STAFF REPORT

TO: Advisory Design Panel **MEETING DATE:** August 25, 2021
FROM: Director of Planning **FILE NO:** ZA-2021-05 & DP-2021-15
SUBJECT: Rezoning and Form and Character Development Permit for Cluster Residential Development at Proposed Lots 37 and 38 Celia Crescent

DRAWING TITLE:
MAIN FLOOR PLAN

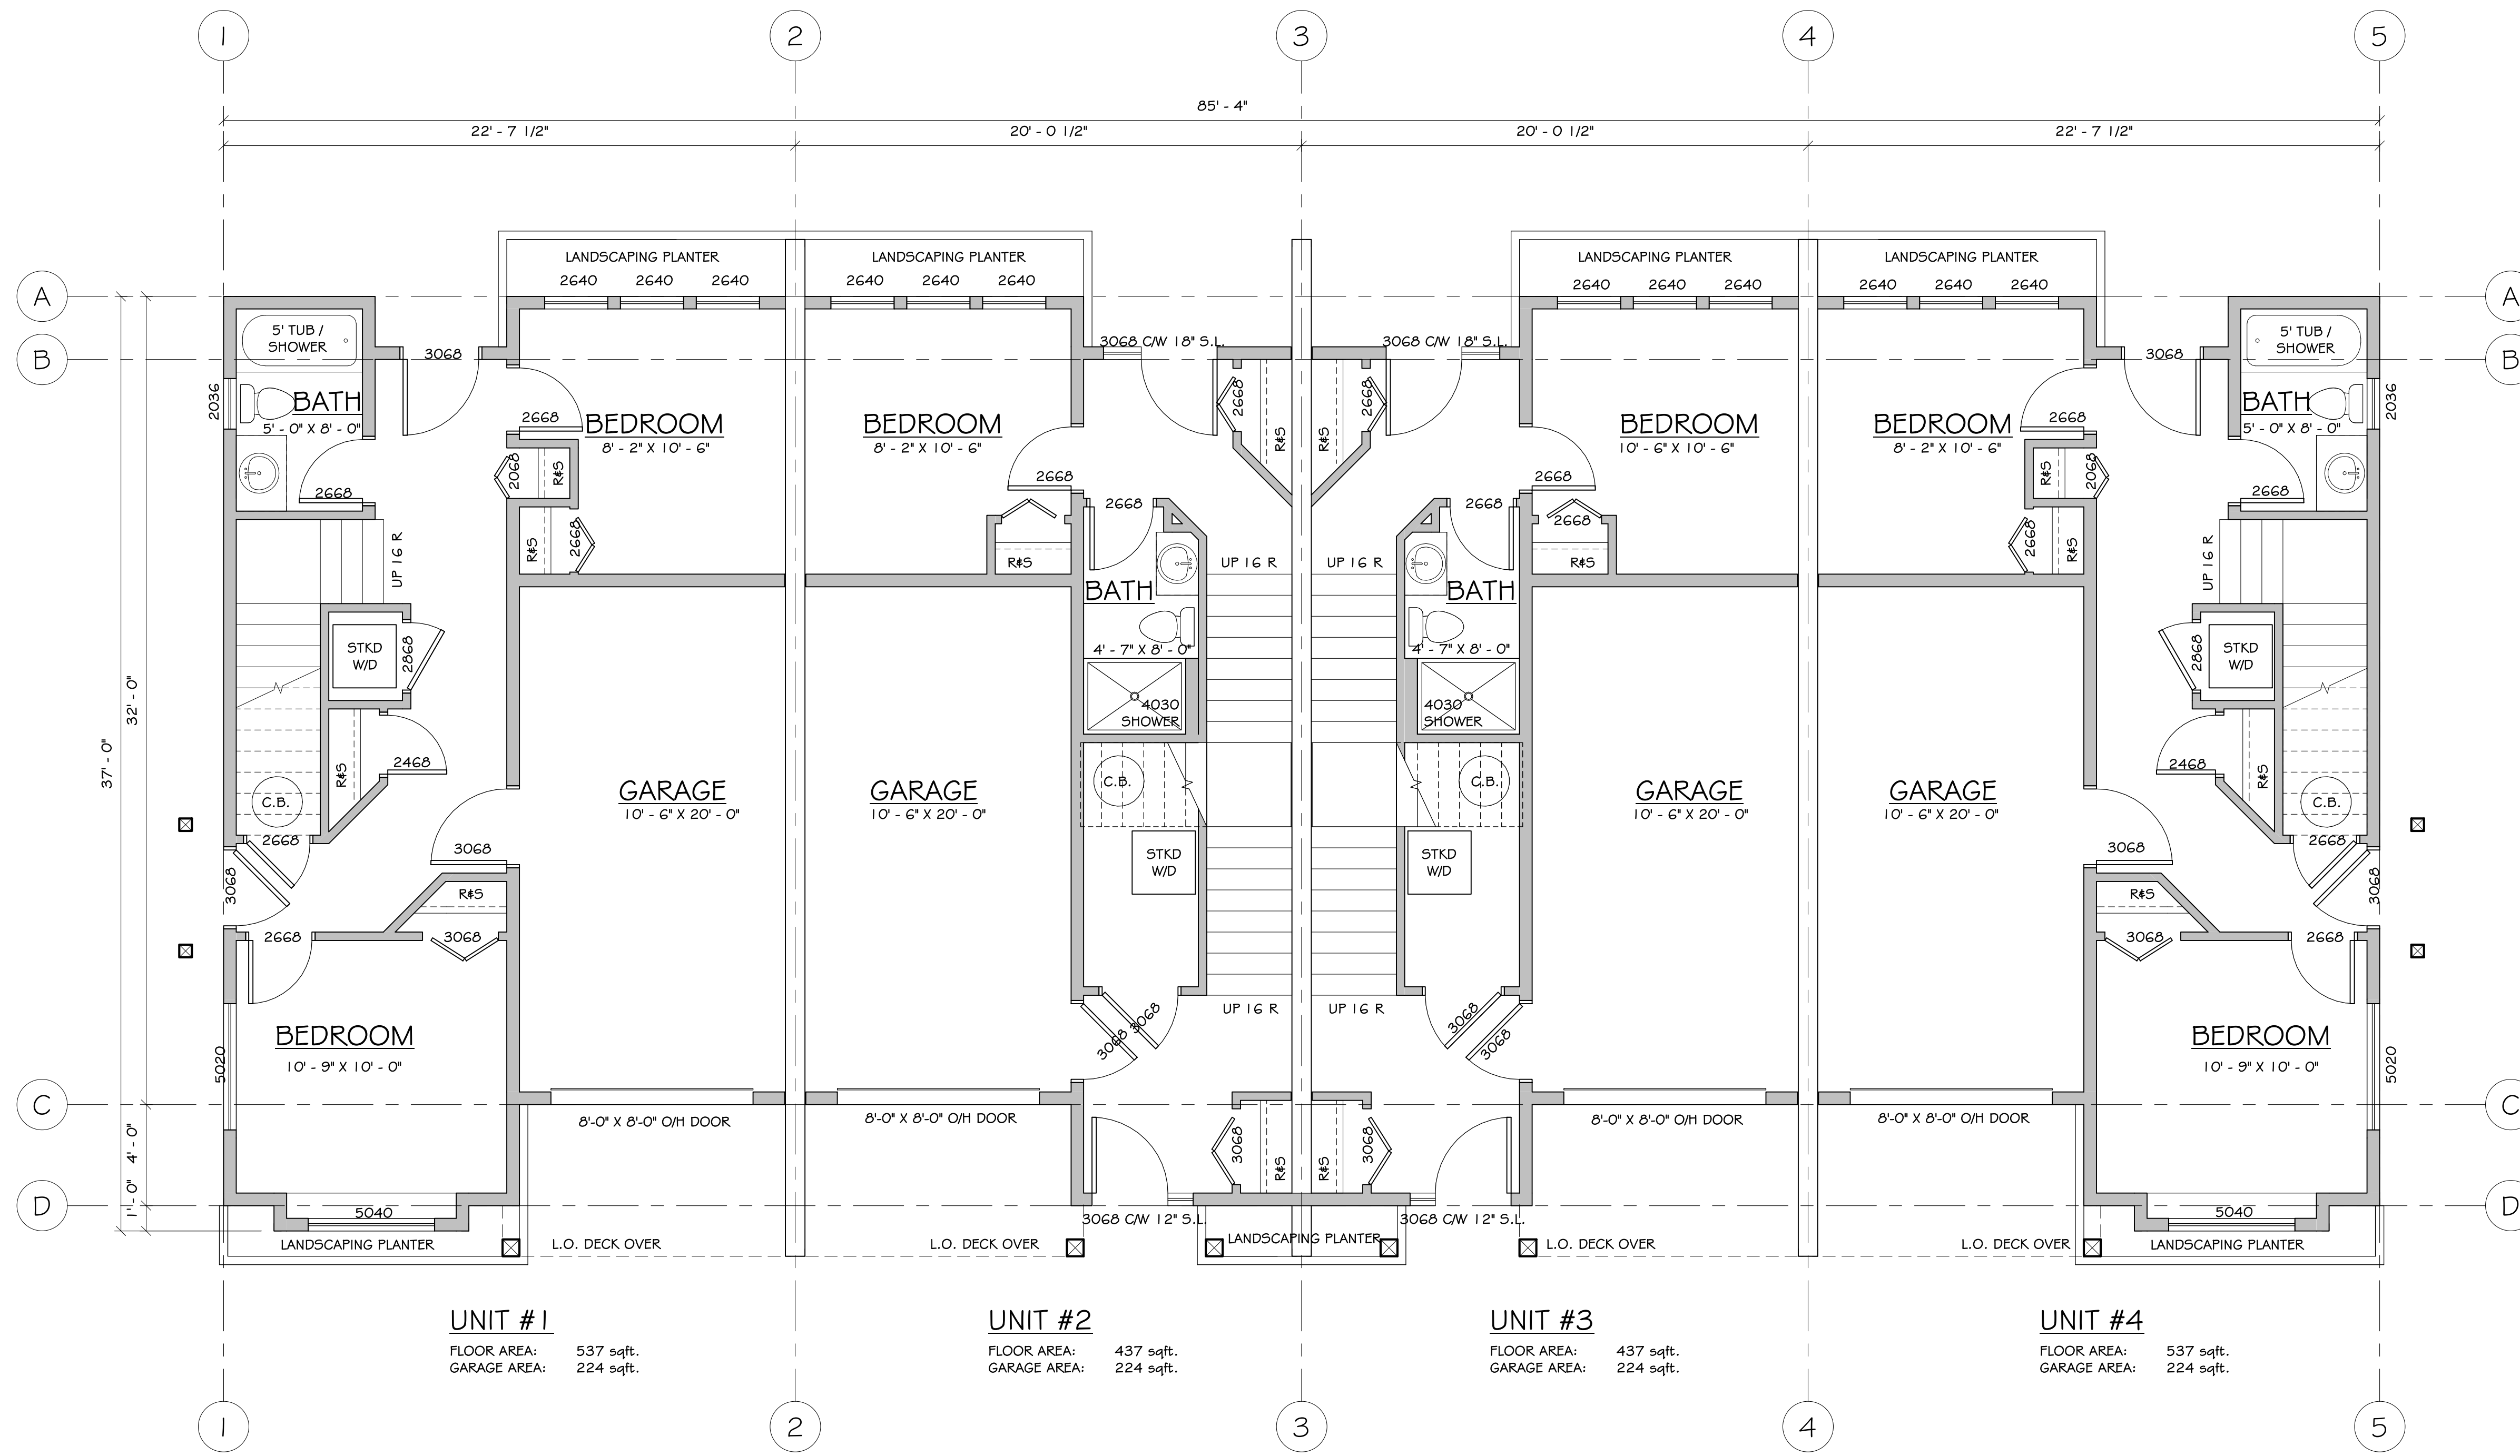
Staff note that the second storey 80% net floor area requirement is not met, due to the garage being excluded from the floor area calculation on the ground floor; however, if calculated by building floor area, this condition is met. Given that this regulation has created difficulty with all development proposals that use this zone, and that it is intended to regulate building form, staff recommend removing it. Form and Character development permits are already in place which provides the ability to regulate form on a case-by-case basis. See previous report on this agenda for detailed rationale for removing this provision in the zoning bylaw.

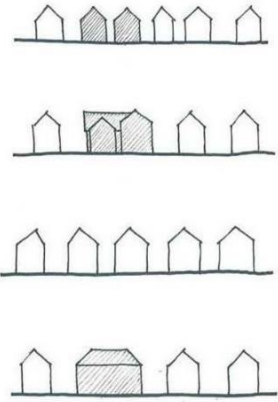
Design lighting to minimize light spill, glare and sky glow by using non-glare full cut-off fixtures.	<i>Lighting plans are not provided, however developer has confirmed that lighting is designed to meet this criteria.</i>	Y

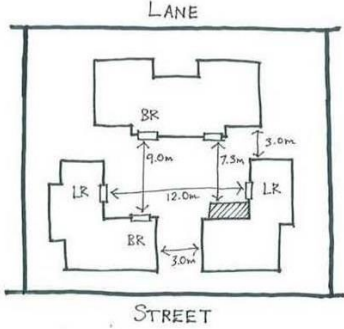
<p>Minimum building separations between units on the same site are preferred, as follows:</p> <ul style="list-style-type: none"> • between side walls of buildings containing a small amount of window area: 3 m • between portions of walls containing windows looking onto active indoor living spaces such as living and dining rooms and kitchens: 12 m • between portions of walls containing windows into other habitable rooms: 9 m • preferred distances in cases (2) and (3) are reduced to 7.3 m to portions of walls containing non-habitable space 	<p><i>Building separations are as follows:</i></p> <ul style="list-style-type: none"> • <i>side wall building separations are closest at approximately 2.2 to 2.8 m</i> • <i>Separation between front faces of buildings with significant windows is 12m or greater</i> 	<p>Y/N</p>
